CCK-2979.00-1-26

UK North Farm Seedhouse

ADDENDUM #4

UK Project #: 2979.0 Seedhouse

A401

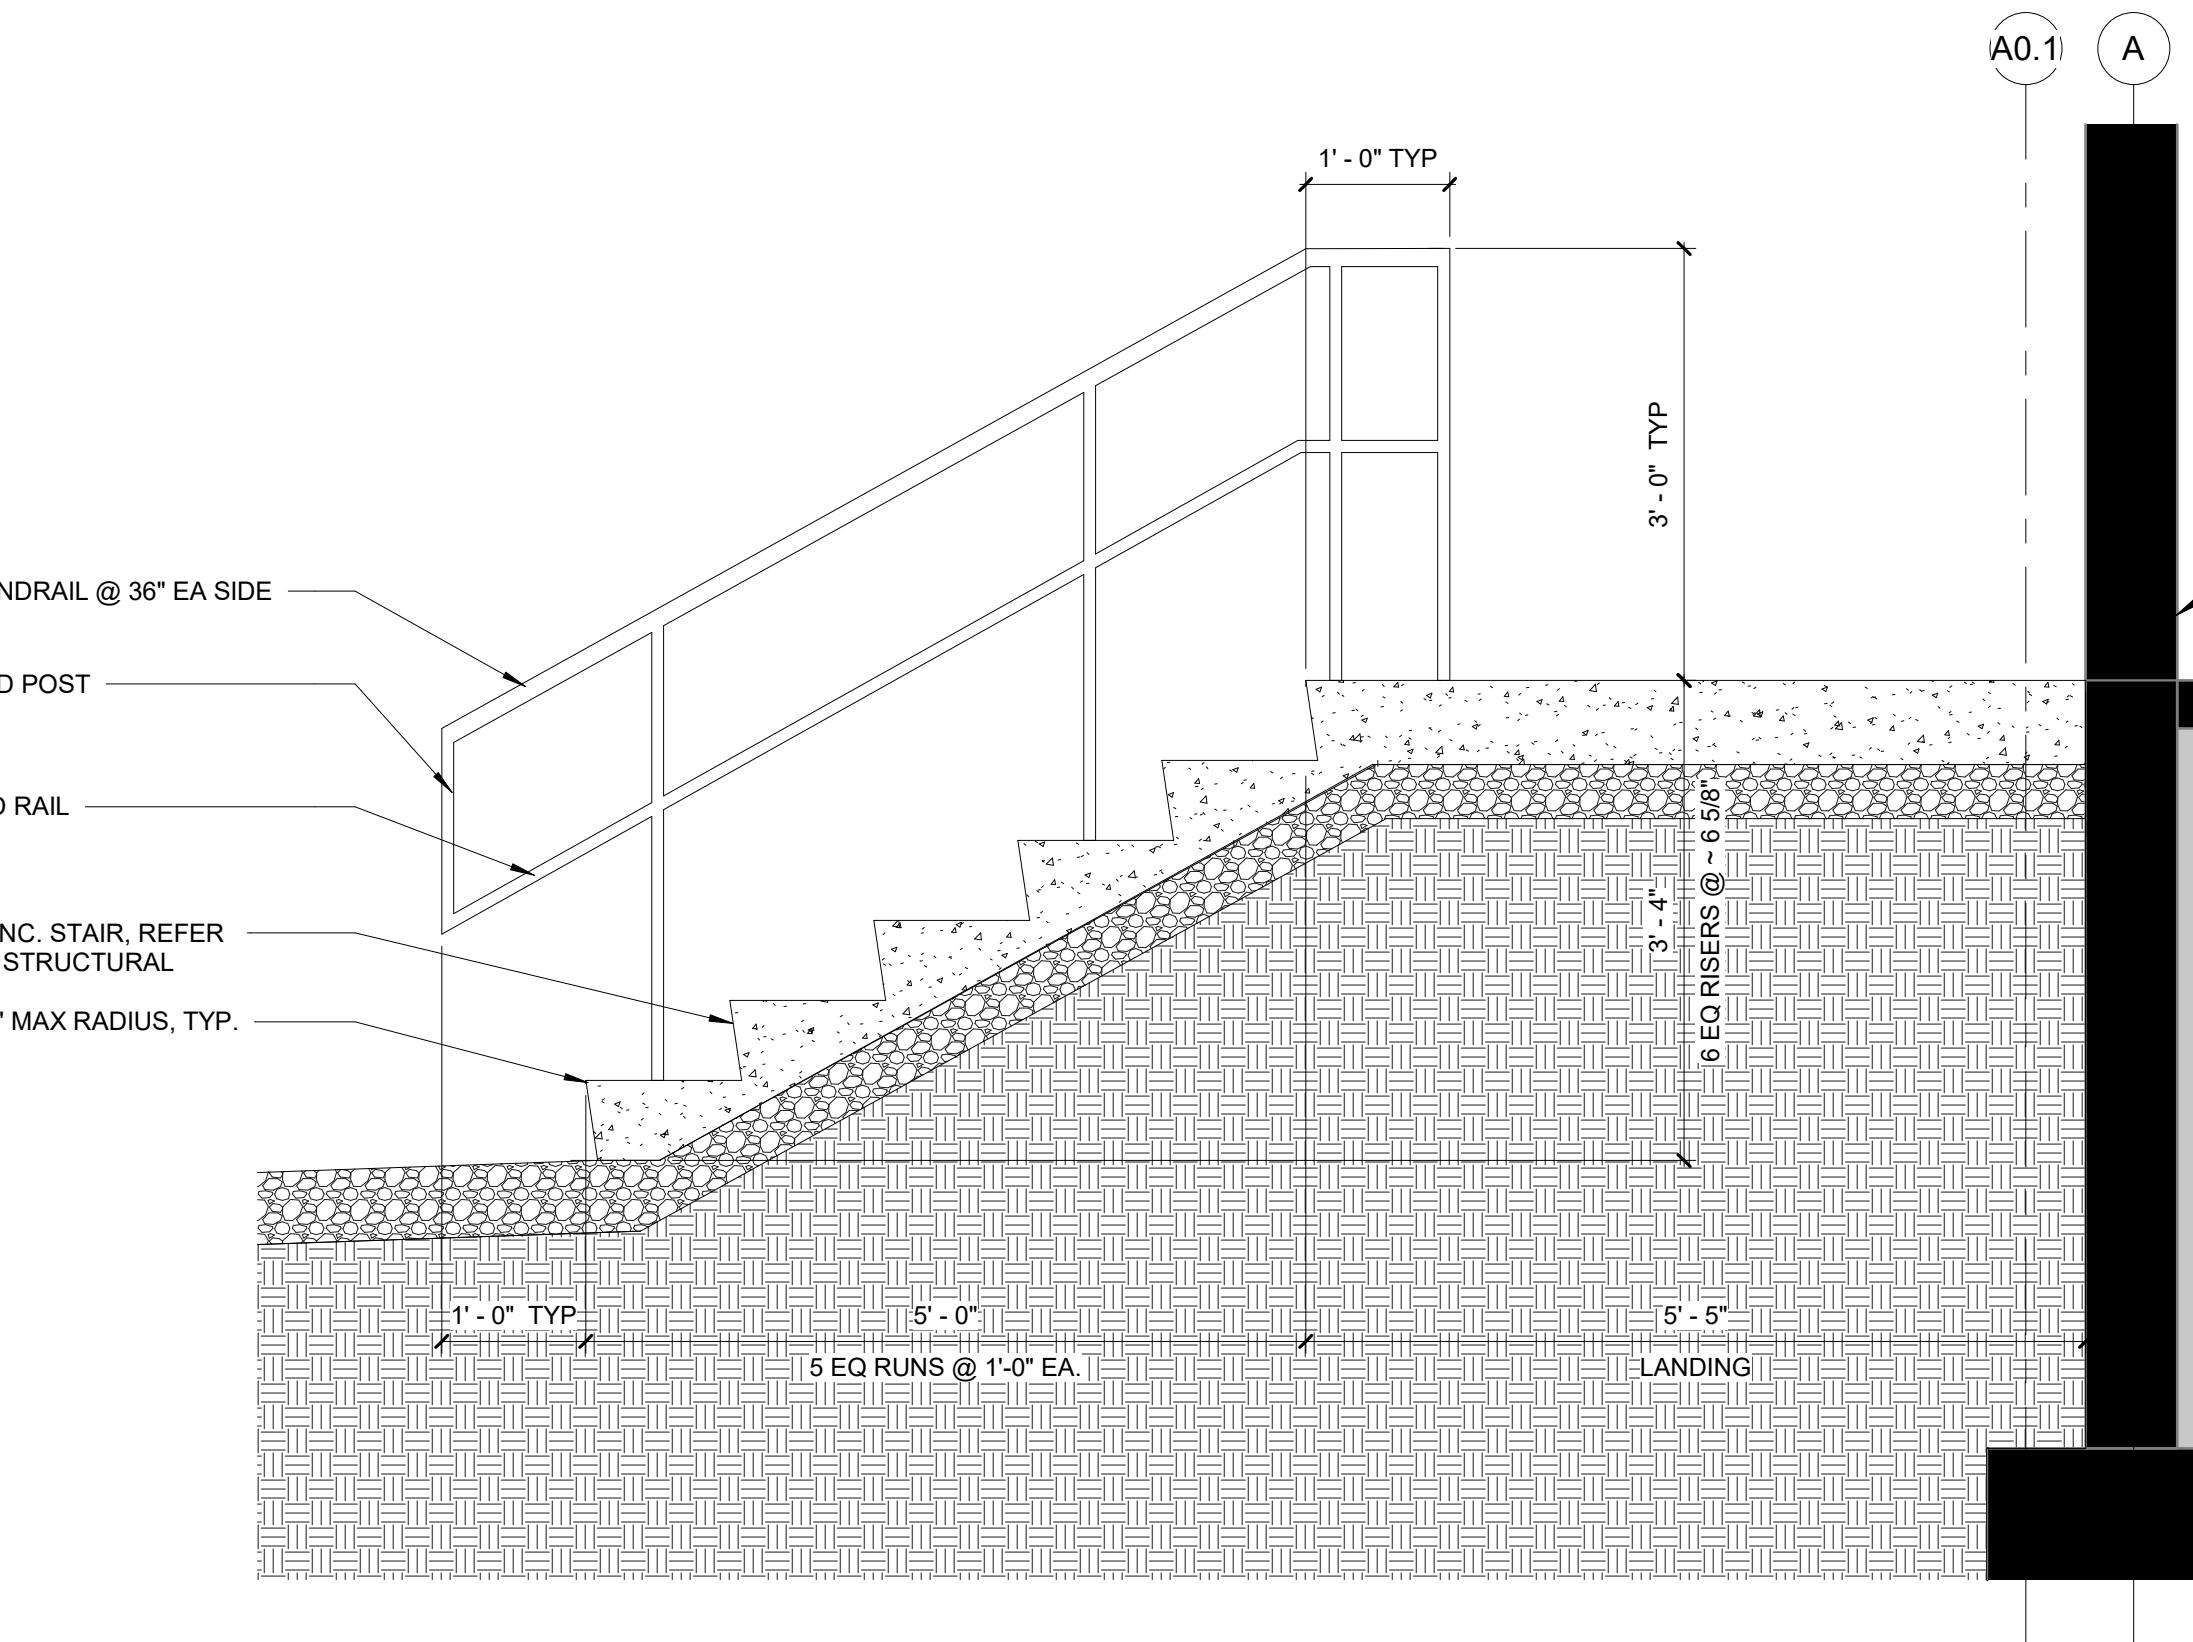
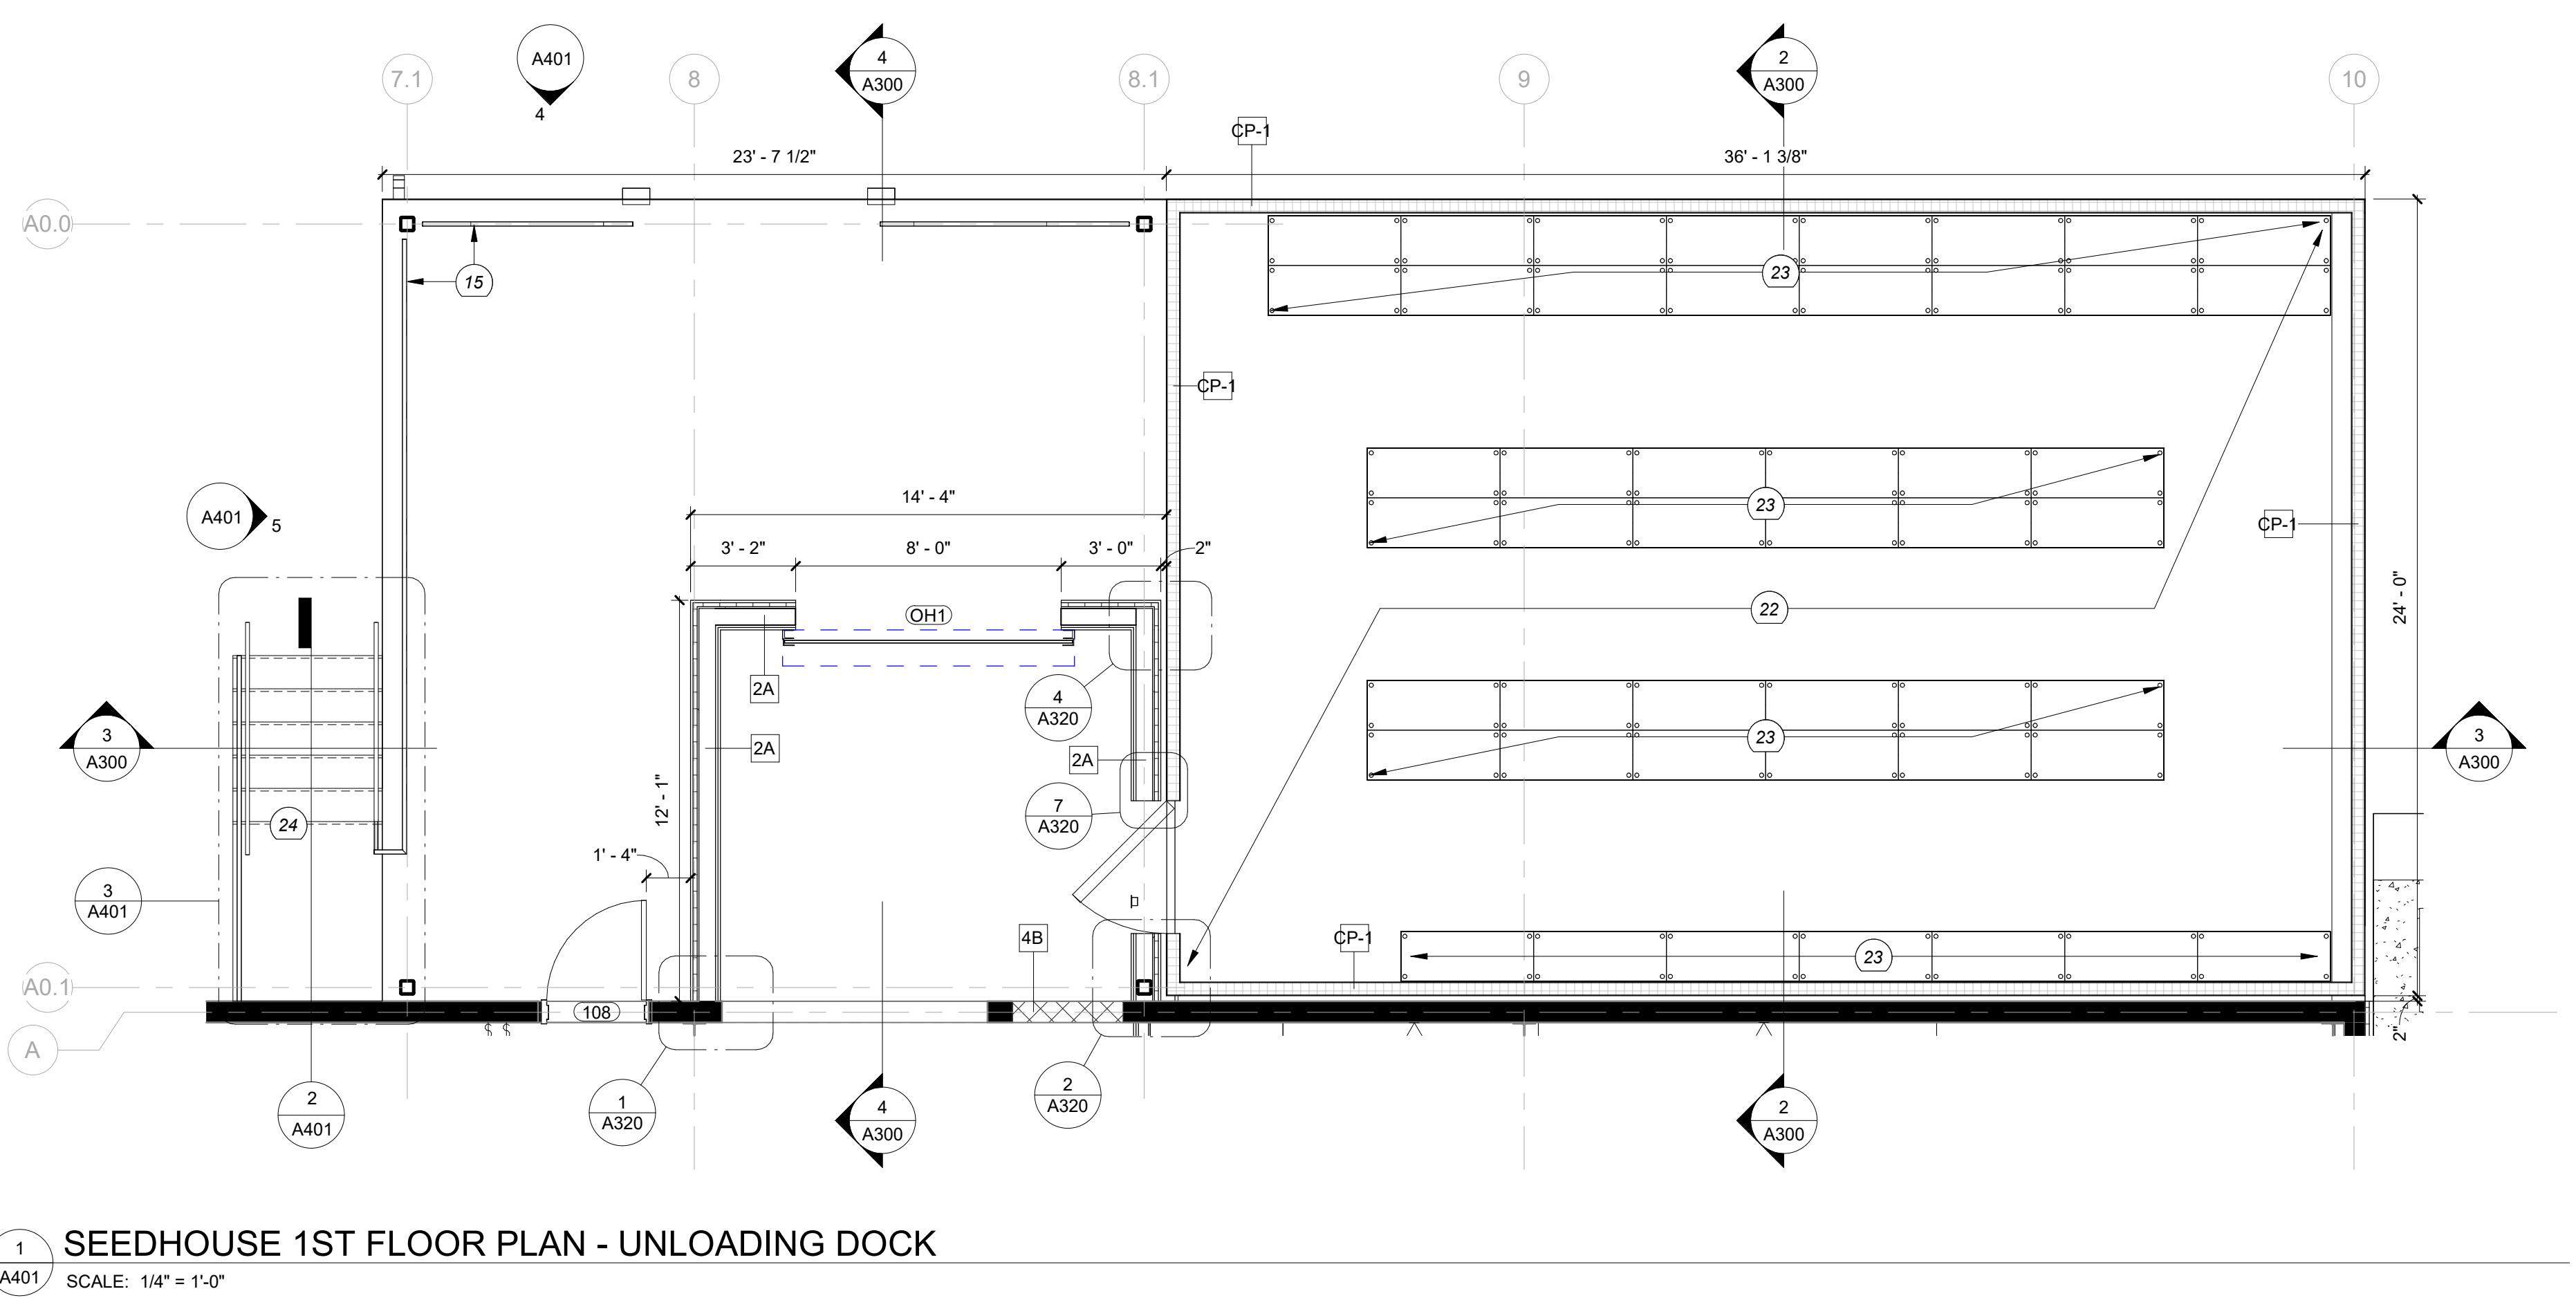
5. Refer to attached revised sheet A401 – VESTIBULE / DOCK PLANS / DETAILS.
 - a. Exterior concrete stair width changed from 4'-0" to 4'-6".
 - b. Exterior concrete stair landing width changed from 4'-0" to 4'-6".

- c. Exterior concrete stair landing length changed from 3'-11" to 5'-5".
 - d. Guardrail and Handrail extents and layout have been updated.
 - e. All Guardrails and Handrails are to be cored / embedded.

- Delete edge angle along outside edge of stair (as shown in detail P/S301).
 - No handrail is to occur along dock guardrails.
 - Stair handrails are to extend a minimum of 1'-0" beyond bottom and top treads.
